Hope Creek Generating Station
Facility Operating License No. NPF-57
NRC Docket No. 50-354

Subject: Response to Request for Additional Information
Request for License Amendment - Extended Power Uprate

Extended Power Uprate Response to Request for Additional Information

Figure 14.110.1a. Comparison of harmonic solutions with Raleigh damping and flat 1% of critical damping. Dashed red line – Rayleigh damping. Solid blue line – 1% flat damping. Nodes 82290 and 86424.

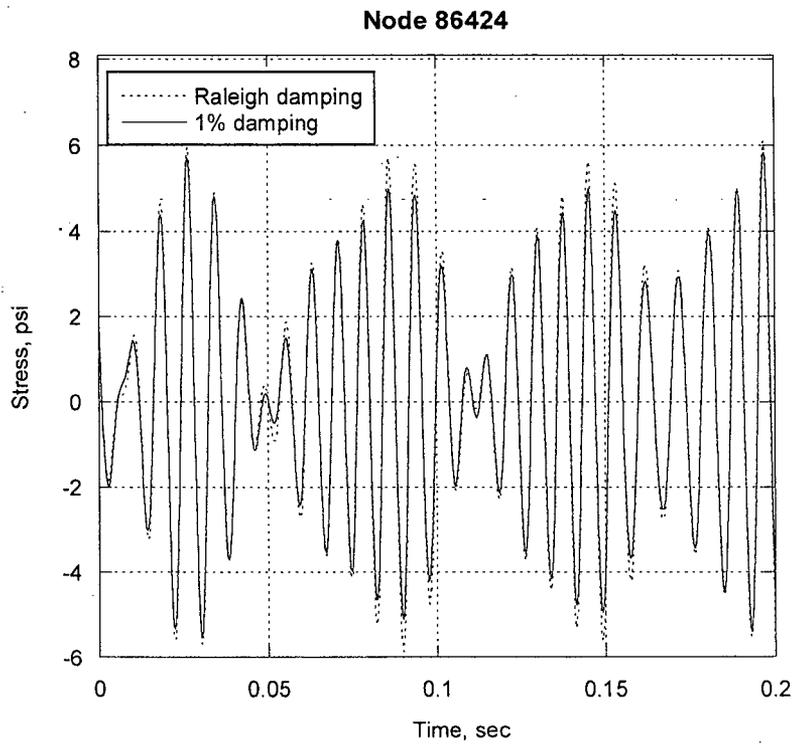
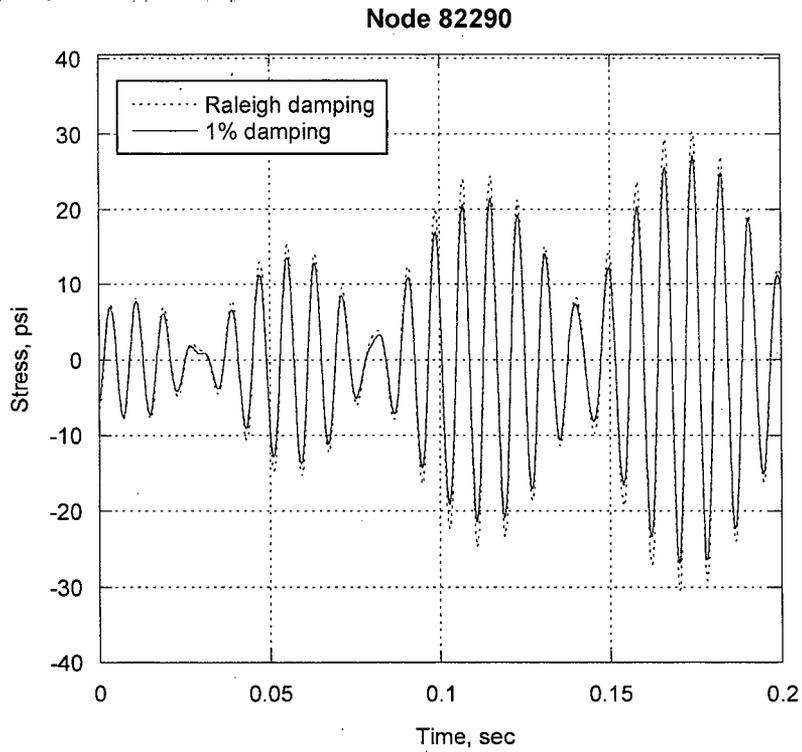
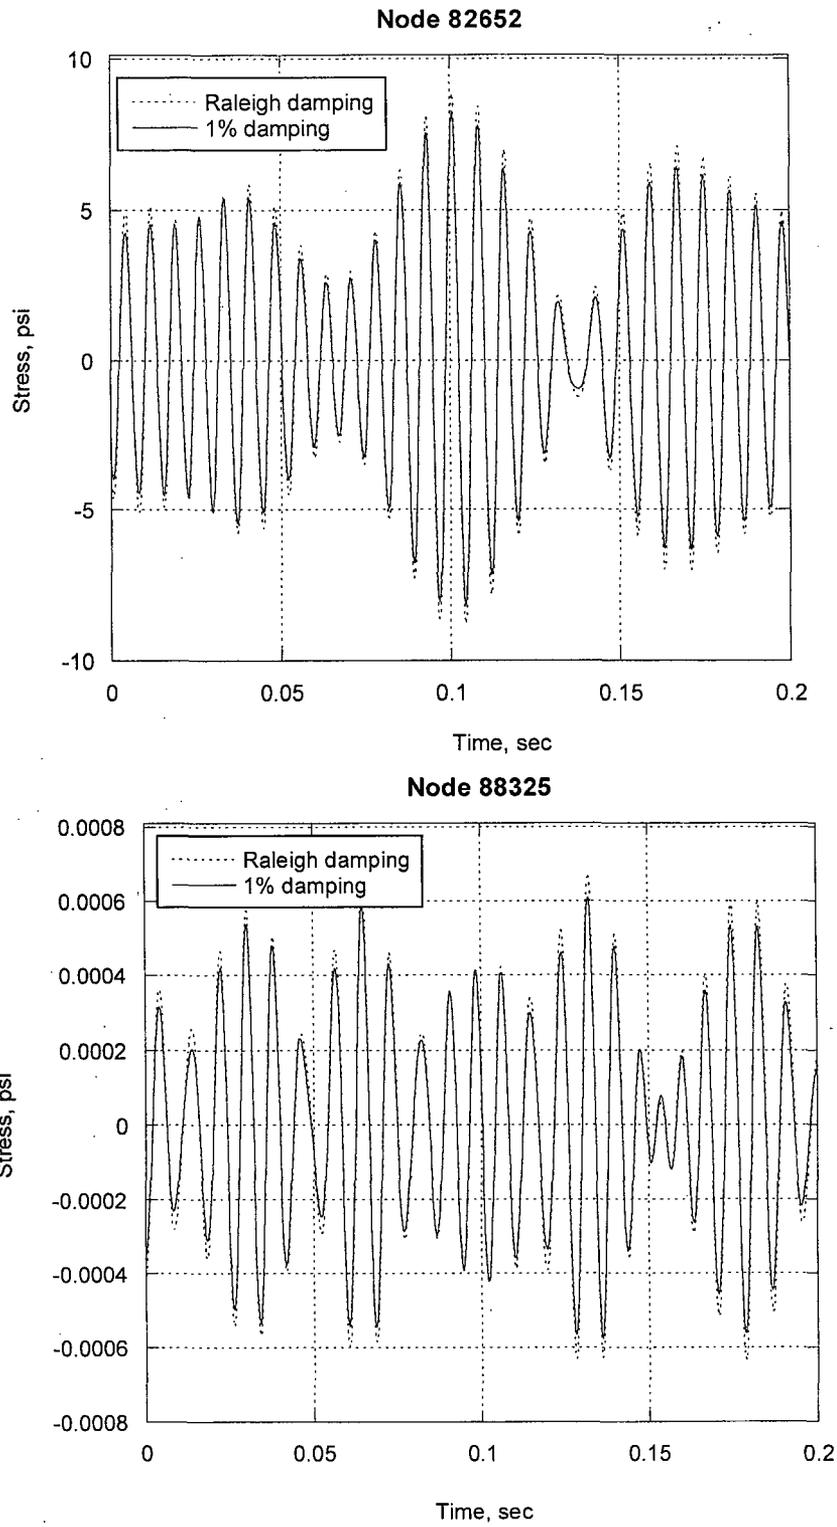
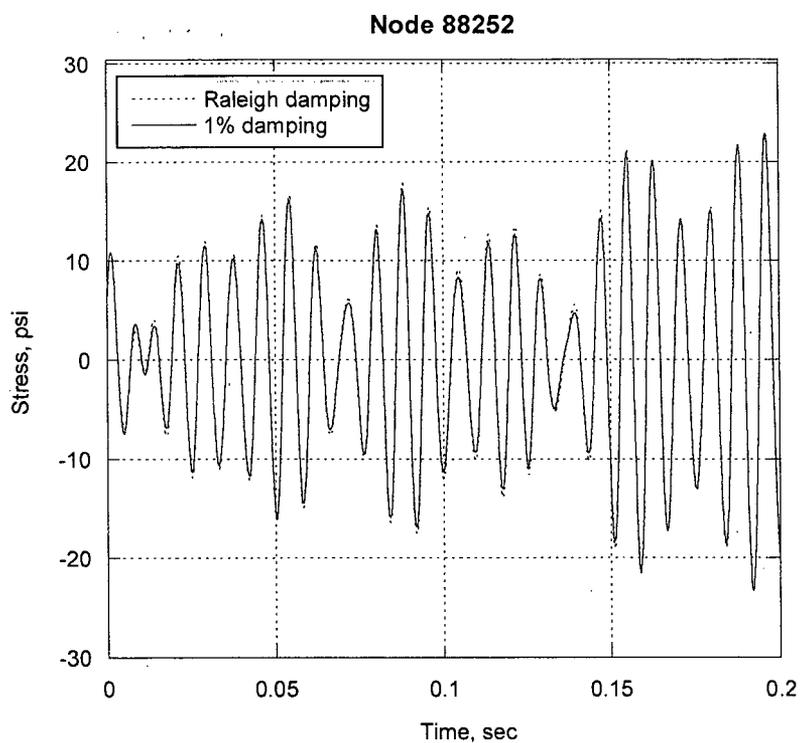
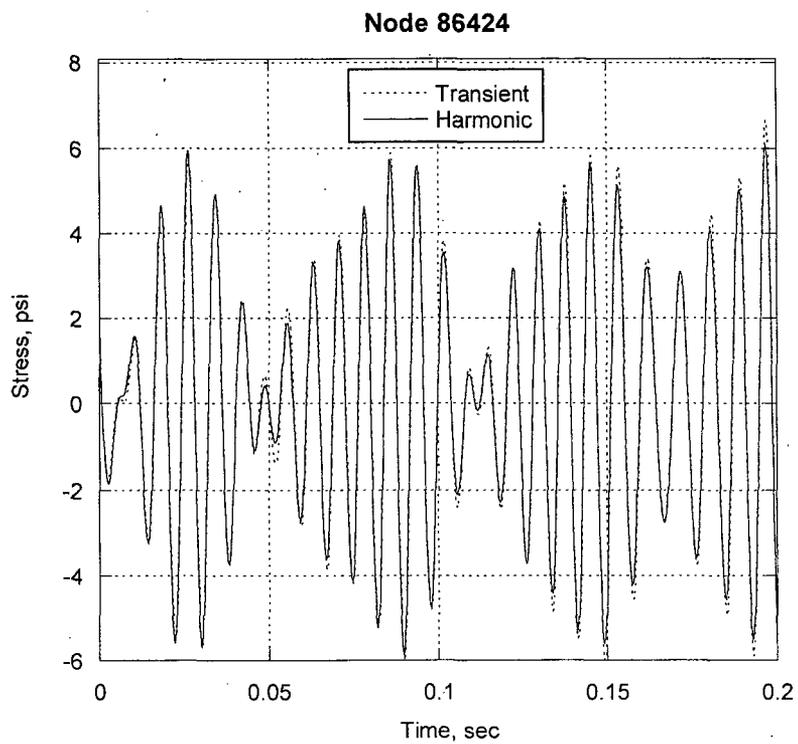
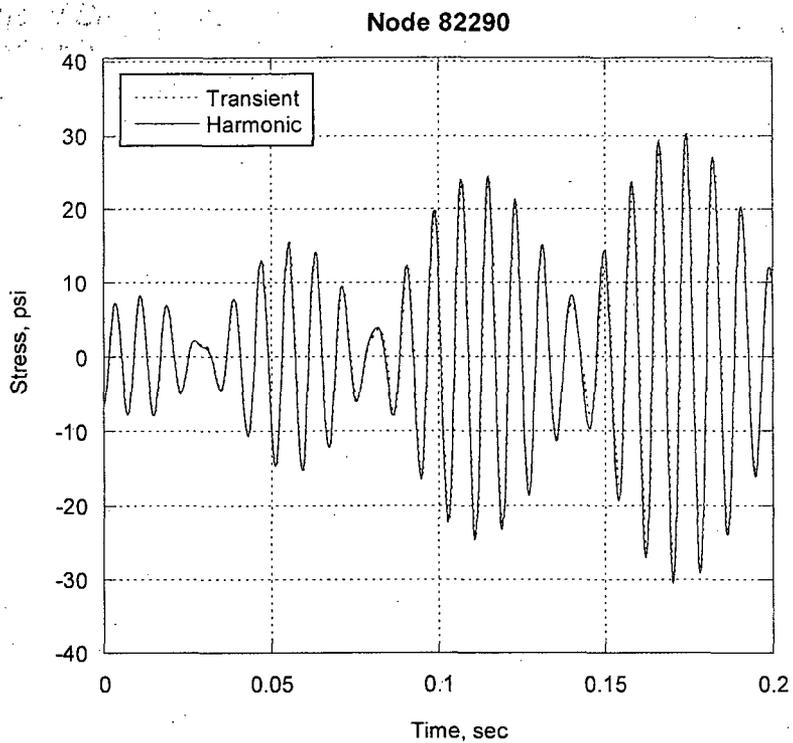
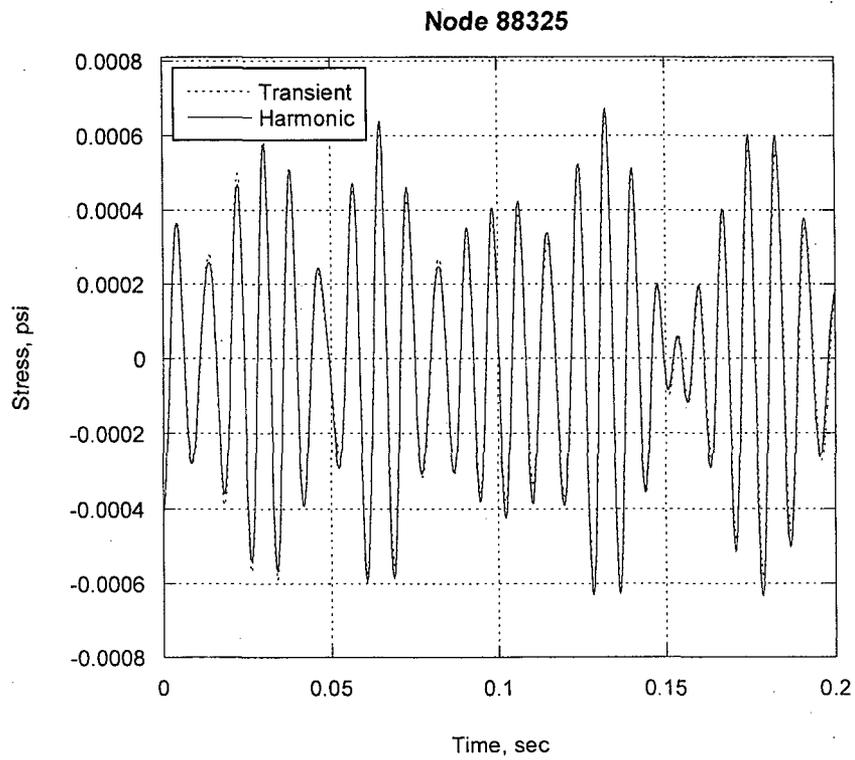
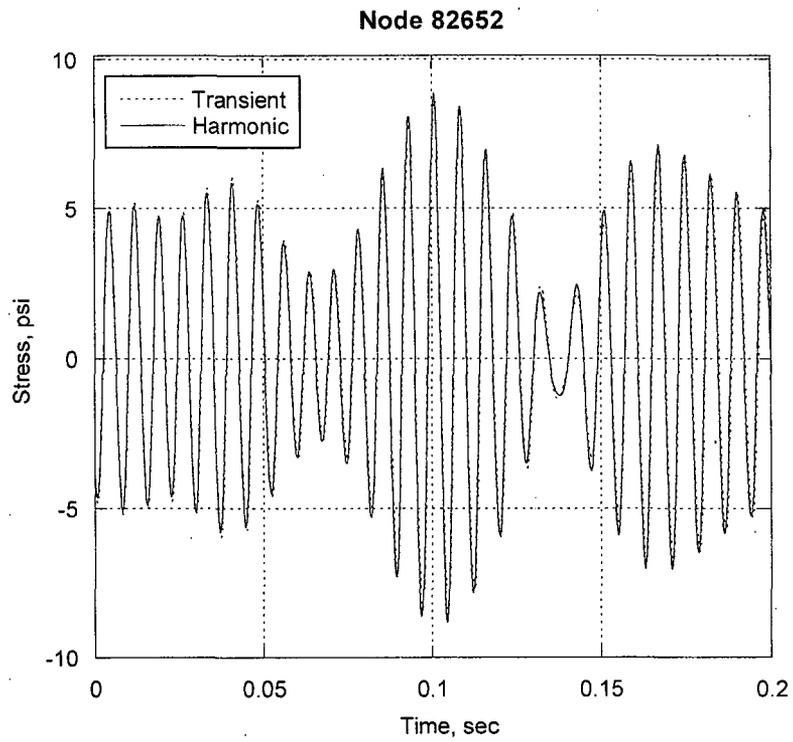
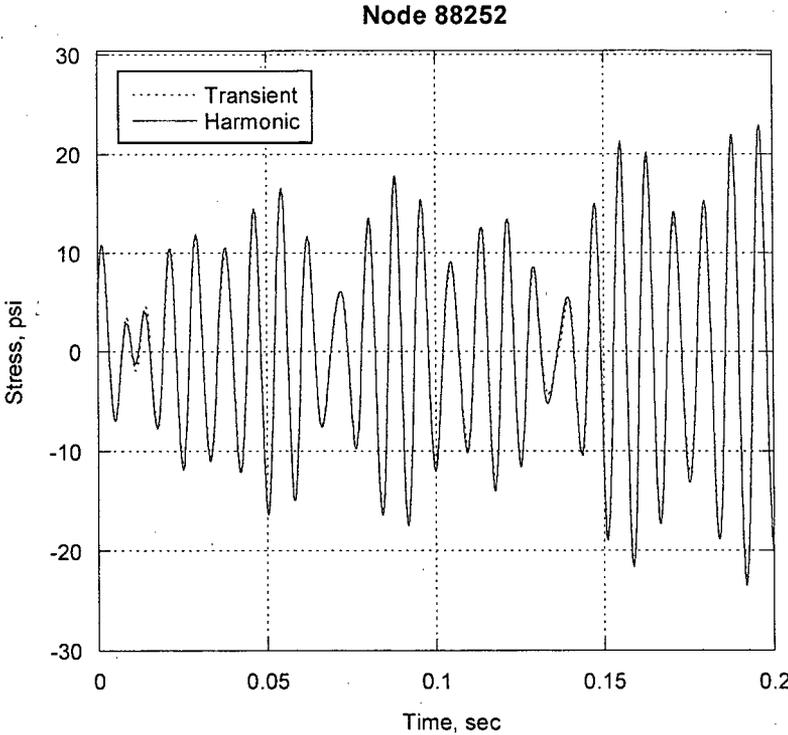
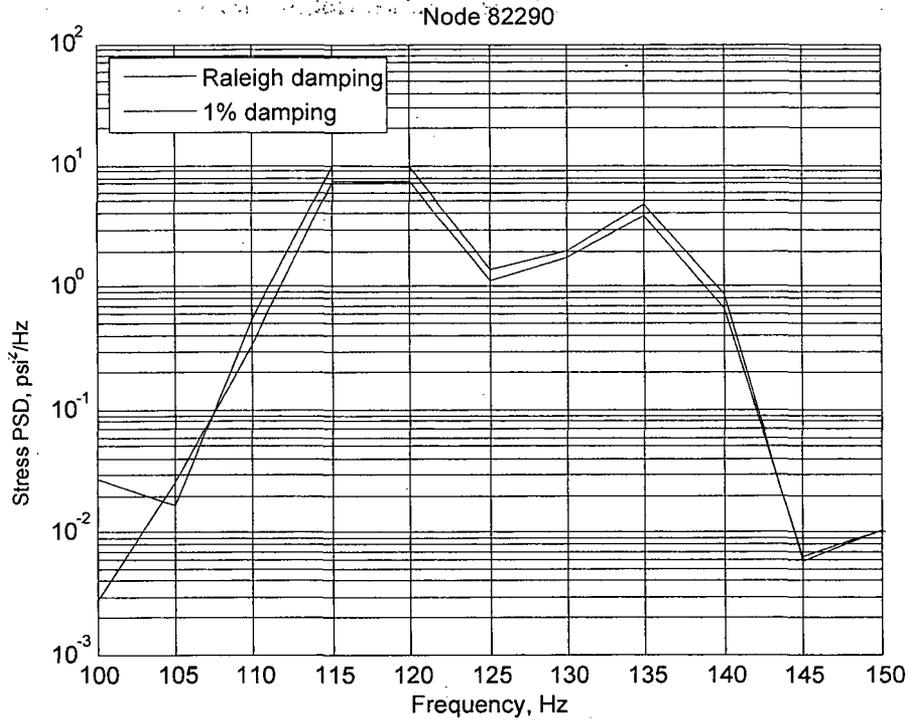
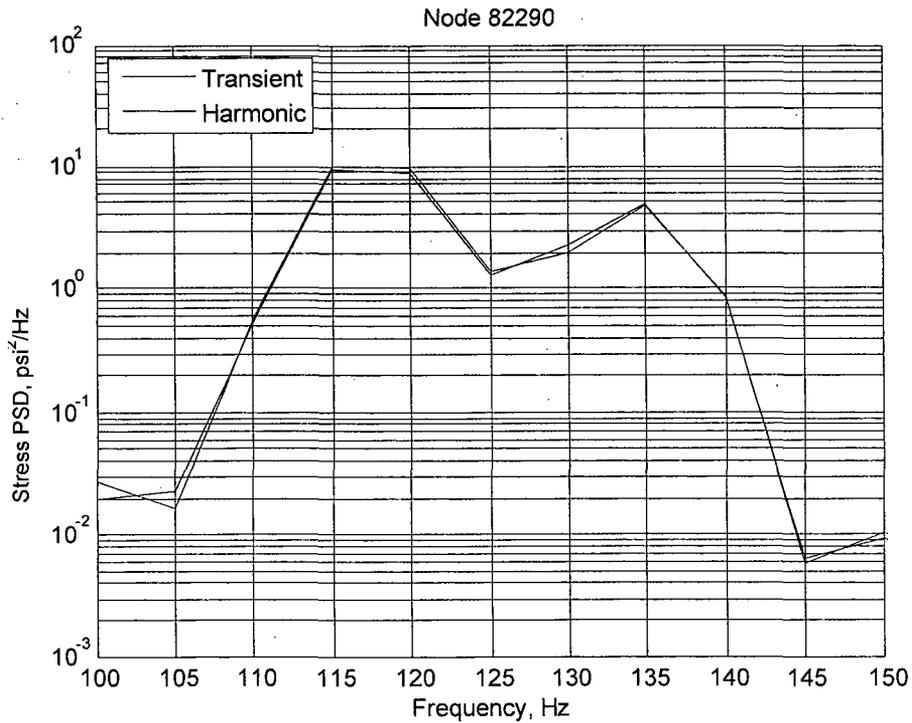
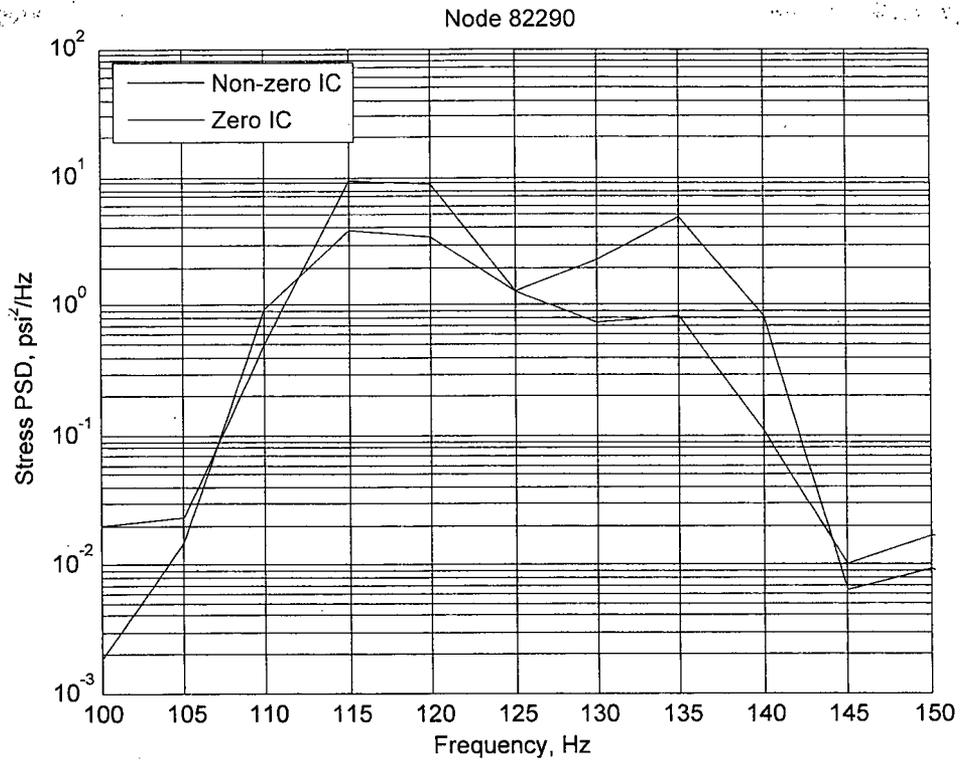
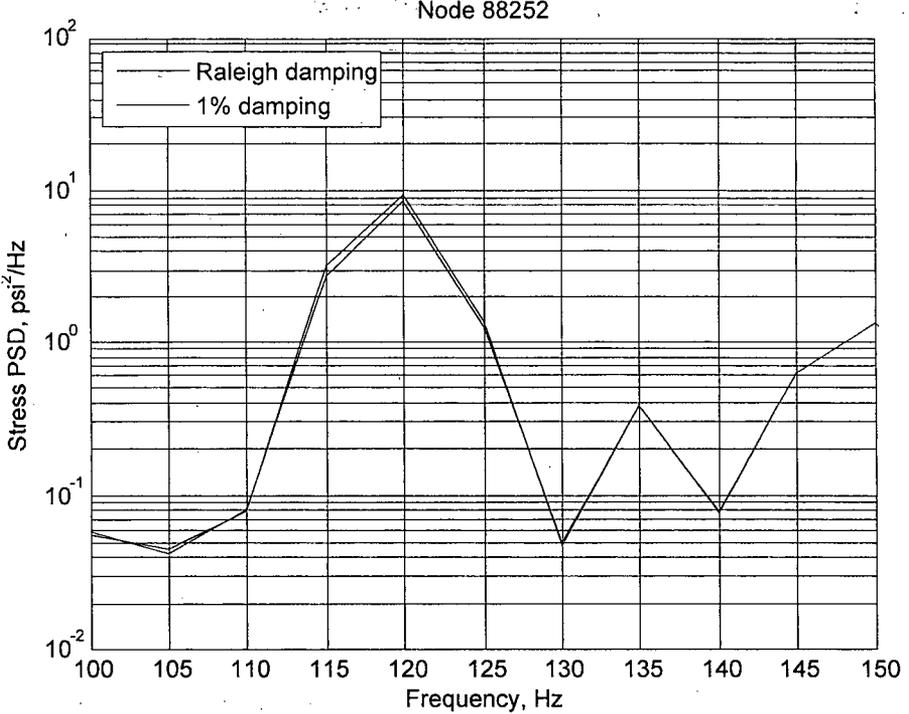
]] when analyzing a full steam dryer model. PSEG could consider an alternative analysis to verify the new approach. For example, a small section of a steam dryer could be analyzed, such as one of the outer hoods, using actual plant loads (such as those from CDI report 07-17P) over all frequencies. The outer hood boundaries could be constrained with pins or clamps. The model should retain the dynamic characteristics of the larger steam dryer model, such as having closely spaced natural frequencies. The analysis should include the following aspects:

- (a) One percent Rayleigh damping would be used for the transient simulations. Estimate the actual damping value at each natural frequency of the simplified model (i.e., small section of dryer) and use them in performing new frequency based simulations. Stress and displacement time histories at high stress locations from both approaches would be compared [[
]]. Maximum stresses and displacements for both approaches would then be compared at several locations on the hood.

- (b) Along with comparing time series computed using the transient and frequency based simulations for a model like the one described in part (a), PSEG should provide comparisons of Fast Fourier Transforms, as specified in the original RAI, and explain any differences between peak levels.

- (c) Reevaluate the frequency simulations considered in Part (a) of this RAI with 1 percent of the critical damping for all the frequencies and the compare the results for high stresses, displacements and alternating stress ratios with those for the transient simulations presented in Part (a). Provide justification for the differences in the results.

The influence of the damping model on the computed stresses is assessed by comparing the harmonic responses at selected nodes. Specifically the calculations (i) and (ii) described above are compared. The Rayleigh damping varies from 0.72% to 1%, one expects, that the stress peaks obtained with the Rayleigh model will be between 0% to 39% higher than when using a 1% damping at all frequencies. The stress and error measures defined above are recorded at the selected nodes in Table 14.110.1. The responses are compared in Figure 14.110.1. The main observation is that the predicted maximum and alternating stresses obtained with the Rayleigh damping model are everywhere higher than those obtained with 1% damping model. This is entirely consistent with expectations. The differences at these sample locations are up to 11%. Higher differences can be expected at other locations particularly ones where the local response is dominated by a mode with natural frequency near 100 Hz. Another interesting observation is that even where stresses are very small (e.g., node 88325) the responses agree to within 9.3% error. Hence, as expected, the use of different damping models tends to scale the response rather than to introduce an additive error.

The next comparison examines the responses obtained with the same damping model (Rayleigh damping), but using different prediction methods – the transient or time marching approach and the harmonic analysis. In the transient analysis, the initial conditions (displacements and velocities) are set from the harmonic analysis results in order to minimize the presence of transients in the response. Mathematically, identical responses are expected and the goal here is to verify whether this is reflected in the computational implementation. The results are tabulated in Table 14.110.2 and depicted in Figure 14.110.2. As expected very good agreement is established overall. In all figures, the agreement is demonstrated in both phase and amplitude and, with the exception of node 86424, the response curves are virtually indistinguishable. For node 86424 (Figure 14.110.2b), the maximum error occurs towards the end of the simulation. The difference in results for this node can be attributed to:

The effect of damping (Figures 14.110.4a and 14.110.5a) is similar to that observed above in the stress time histories, i.e., the PSD corresponding to the Rayleigh damping model is generally larger since the effective damping in this frequency range is smaller. From Figure 14.110.4a, the effect is seen to be frequency dependent. When using the same damping models the PSDs extracted from the harmonic and time-marching calculations (the latter being started with transient-free initial conditions) are in excellent agreement (Figures 14.110.4b and 14.110.5b). The small mismatches (recall that these results are plotted on logarithmic scales) near 100 Hz and 150 Hz are due, in part, to leakage into neighboring bins when computing the PSD. Finally, the PSDs obtained from the transient simulations initiated with the transient free solutions and with zero initial conditions are compared in Figures 14.110.4c and 14.110.5c. These plots
